SUBJECT: Forwards 60 day response to NRC 950207 RAI in support of INEL work under NRC contract to update Reg Guide 1.154, "Format & Content of Plant Specific PTS SARs for PWRs," including End Path Procedures (EPP) EPP-11 & EPP-16.

H. B. ROBINSON STEAM ELECTRIC PLANT, UNIT NO. 2  
DOCKET NO. 50-261/LICENSE NO. DPR-23  
60 DAY RESPONSE TO REQUEST FOR INFORMATION DATED FEBRUARY 7, 1995

H. B. ROBINSON STEAM ELECTRIC PLANT, UNIT NO. 2  
60 DAY RESPONSE TO REQUEST FOR INFORMATION DATED FEBRUARY 7, 1995  
ITEMS 1 THROUGH 7

FIGURE  
15.1.5-1

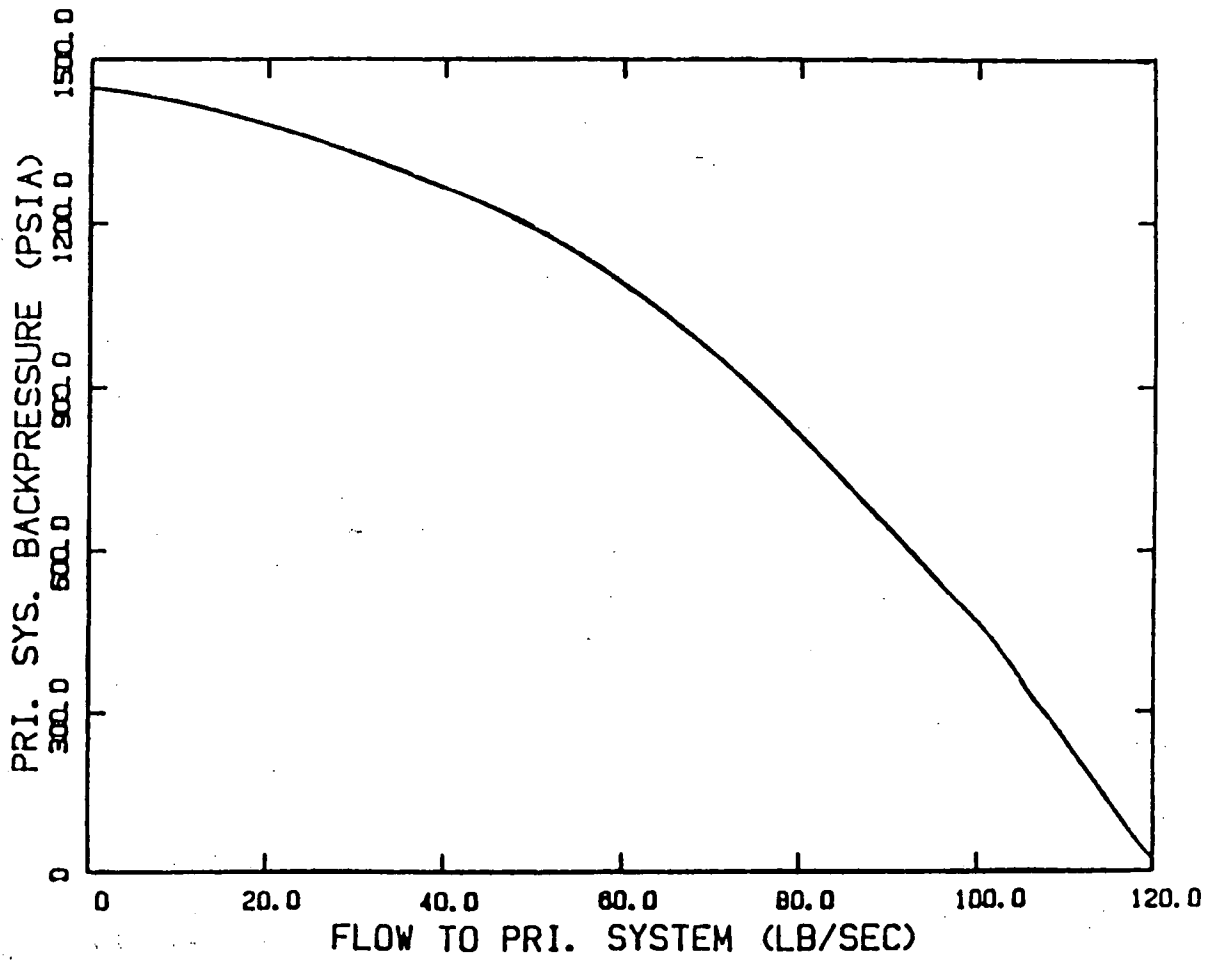
"The pump curves for both HPI pumps and a single HPI pump. The curves should describe the mass flow rate from the pumps as a function of system pressure."

Safety Injection delivery curves are attached as Reference 3. The curves are intended to be conservatively low estimates.

- a. Two pump delivery is attached as Updated Final Safety Analysis Report (UFSAR), Figure 15.1.5-1. The figure is taken from Figure 2.1 in Siemens report XN-NF-84-74 Supplement 3, "Confirmatory Analysis of the Steamline Break Event," January 1985. It also is presented as Figure 2.5 in Siemens report EMF-89-081, "Plant Parameters for H.B. Robinson, Unit 2," Revision 4.
- b. A single pump delivery curve is attached and titled Figure 3.4. This figure will be included in the next UFSAR revision and is derived from the draft Siemens report EMF-95-032 "Main Steam Line Break Analysis for H.B. Robinson Unit 2," and is based on 150% of Table 2.31 in EMF-89-081.
